BCA & ACCESS COMPLIANCE REVIEW

Proposed KCC Redevelopment

Katoomba Christian Convention

DATE_8TH FEBRUARY 2018

2.6.7.1 AUDITORIUM

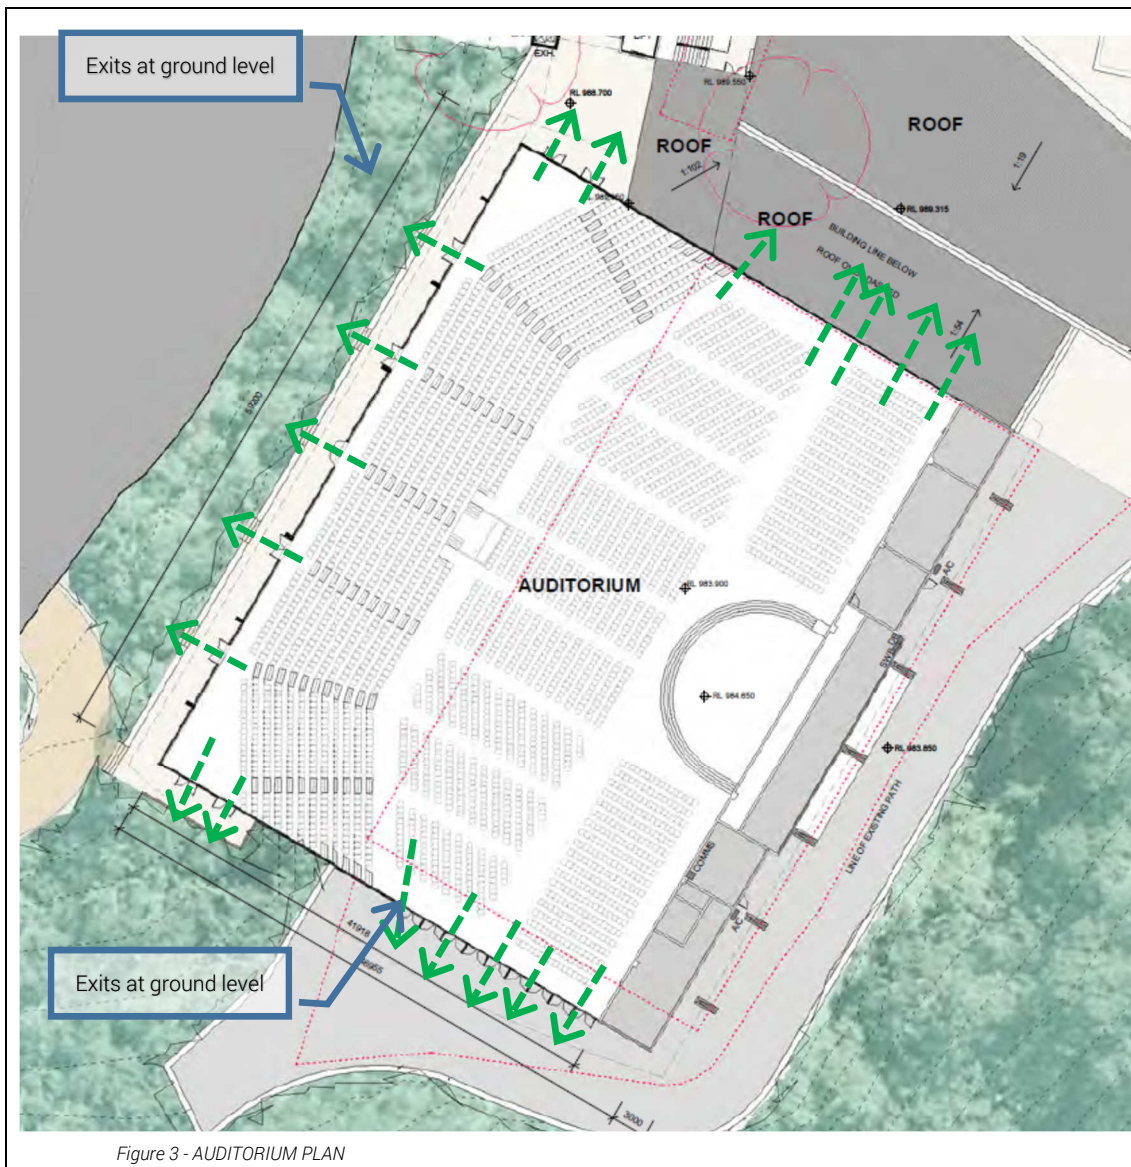
The Auditorium requires multiple exits and a total of 35m of exit width for the 3,500 occupants.

The individual exit width is to be between 1m and 3m clear through door ways.

Generally a typical double exit door with panic bars will provide a clear exit width of about 1.7m and therefore a total of at least 21 double door exits are required. The current design has a number of exits indicated around the perimeter of the building, as indicated in the following figure, which are to include the necessary exit width 35m.

Figure 4 – Level 1 Breakout Area Plan

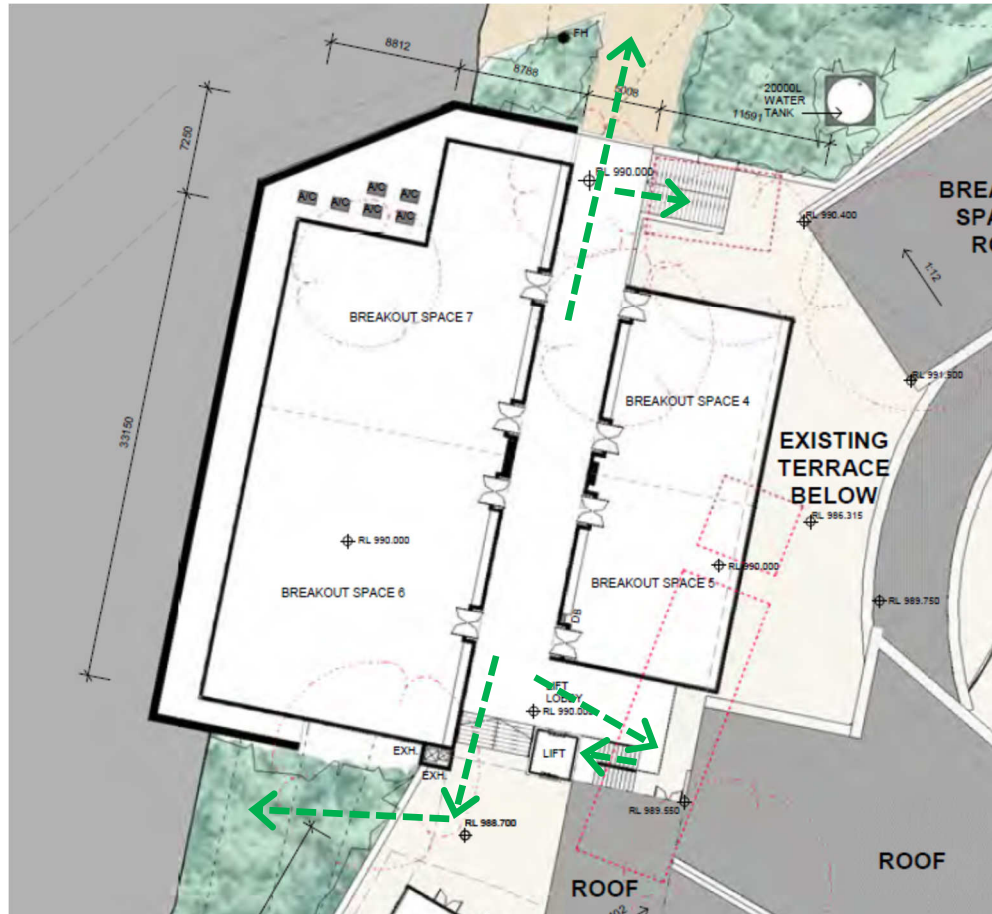
The two breakout spaces on the upper level have a total of 950 occupants and therefore require multiple exits and a total exit width of at least 9.5m. Assuming each exit has a width of 3m a total of at least 4 exits are required. The current design includes 4 exits, two at ground level and two via stairs to the main terrace and plaza level.

Figure 5 - Breakout Space Plan

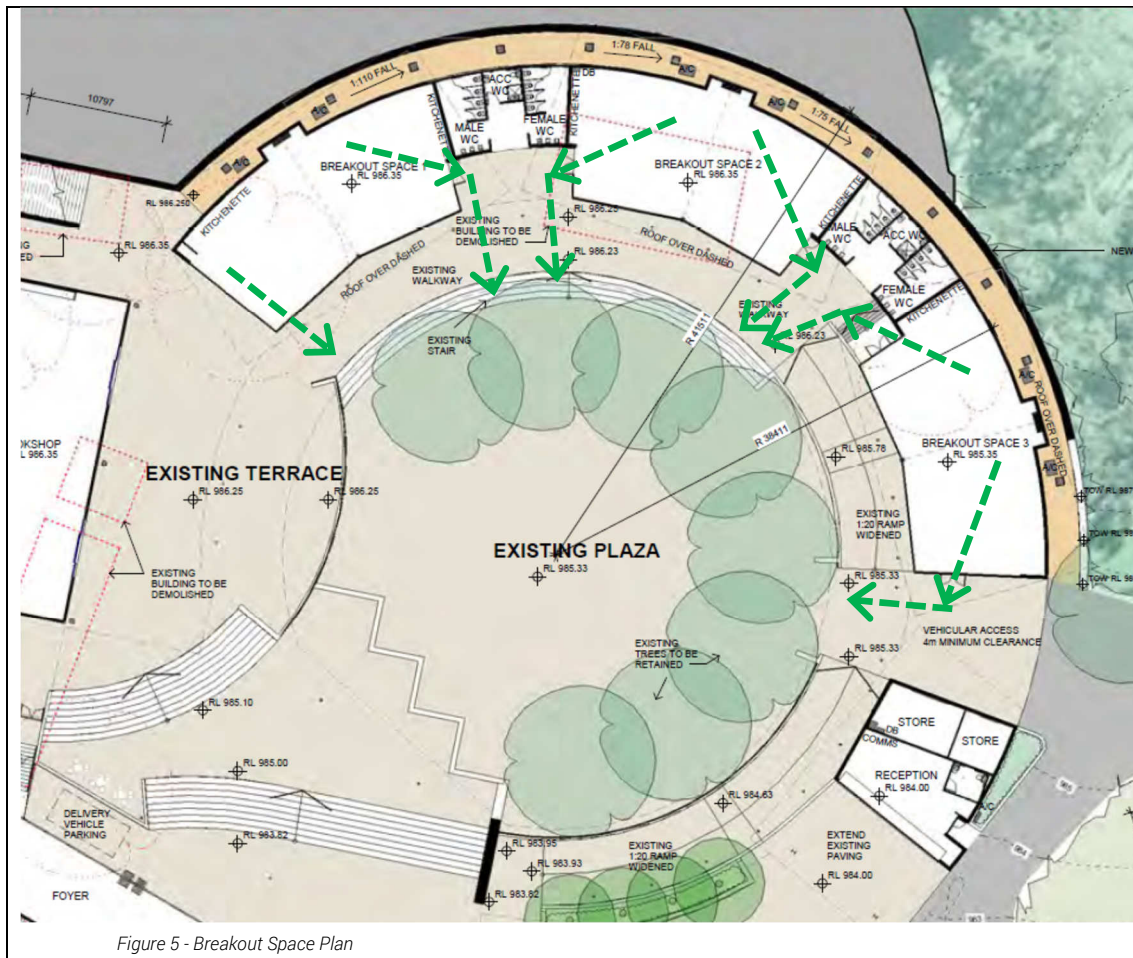
There are three double break out spaces located around the plaza area. Each half of the double space accommodates approximately 105 occupants and is provided with a double door entry that provides an exit directly out to the plaza area. The plaza area is a large open area that is vehicle accessible and therefore can be considered as an open space for evacuation.

A double door entry general has a clear width of 1.6m and therefore will be sufficient for the number of occupants. As each breakout space has two exits the doors are to swing outwards in the direction of exit.

Figure 6 – Eco Lodge Ground Floor Plan

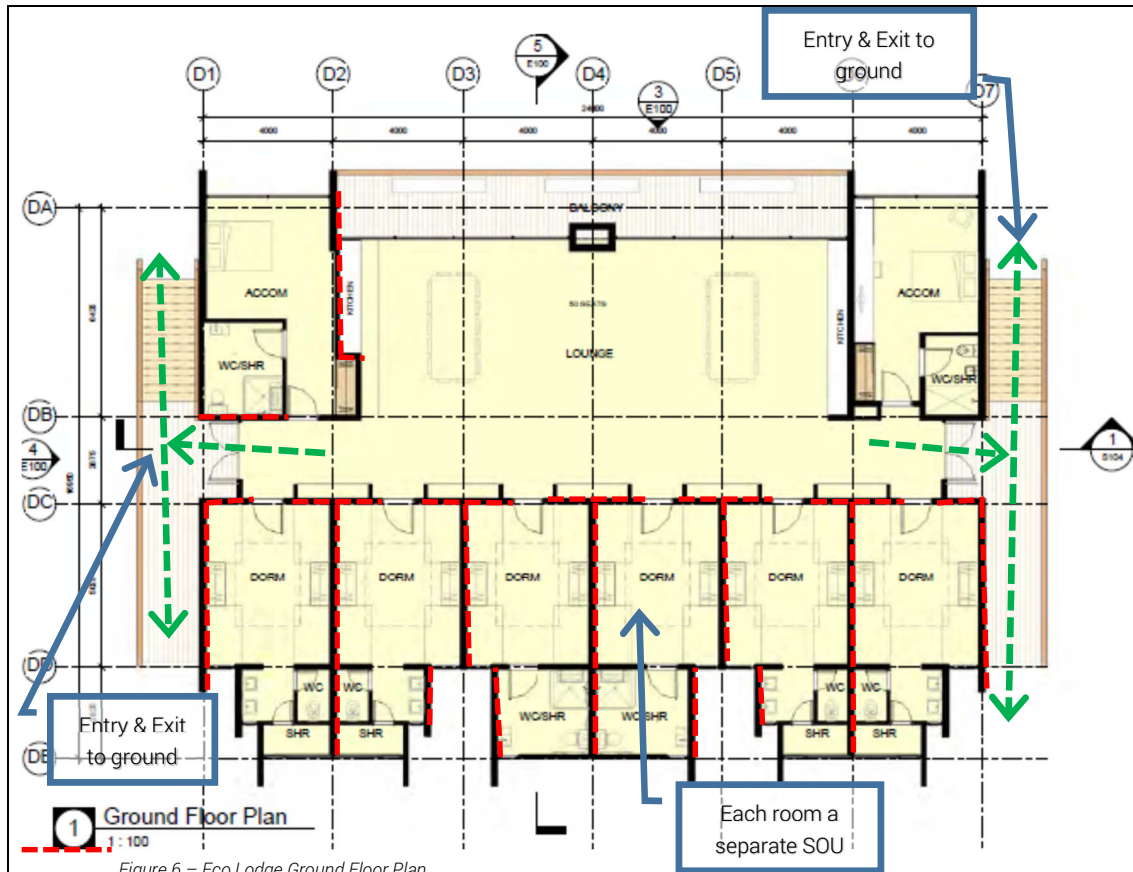
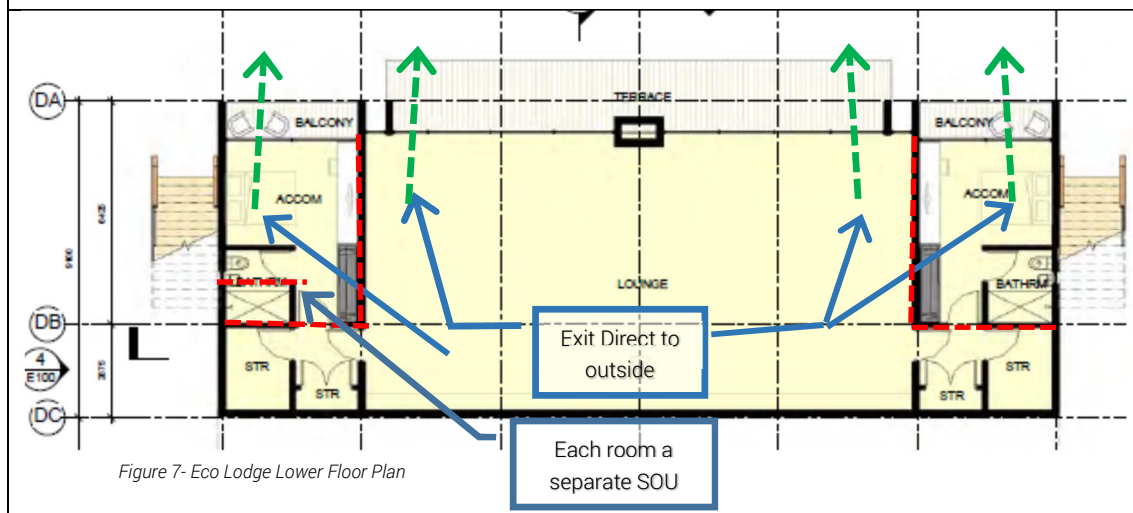
The upper floor of the Eco Lodges are provided with an entry/exit at each end of the building therefore meeting the exit requirements. The lower level of the Eco Lodges are provided with exits directly to the outside as indicated in the images below.

2.6.7.1 ECO CHALETS

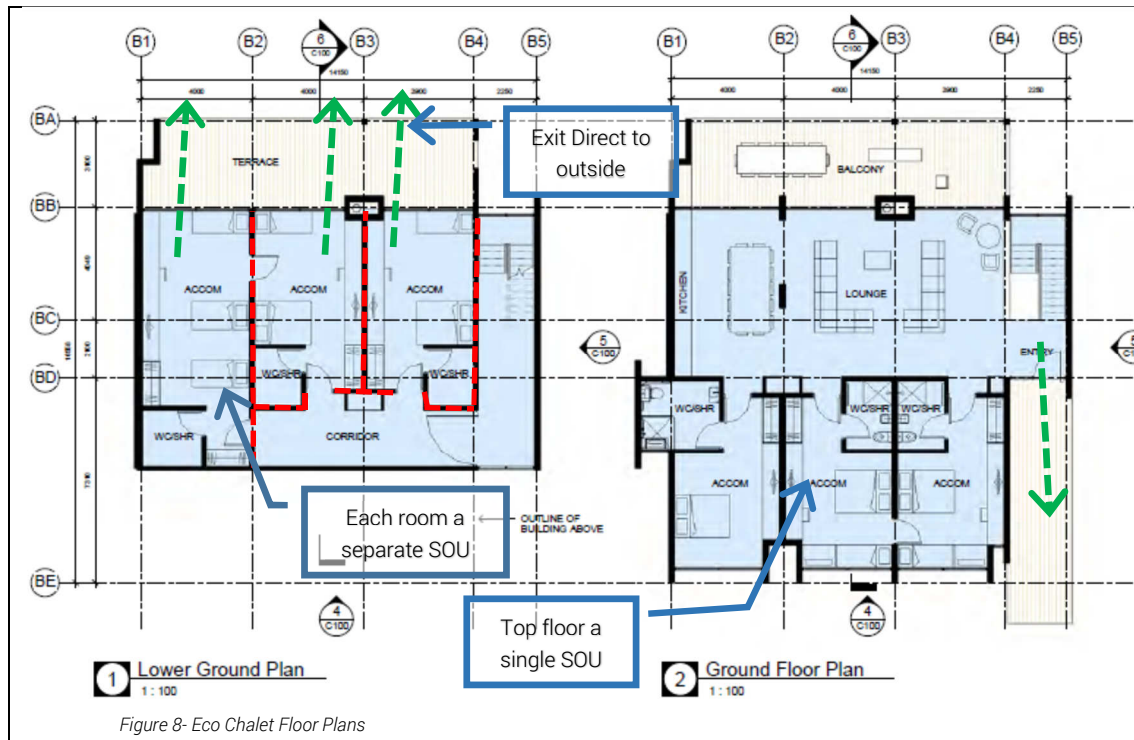
The upper floor of the Eco Chalets are provided with an entry/exit to one end of the building therefore meeting the exit requirements.

The lower level of the Eco Chalets are provided with exits directly to the outside as indicated in the images below.
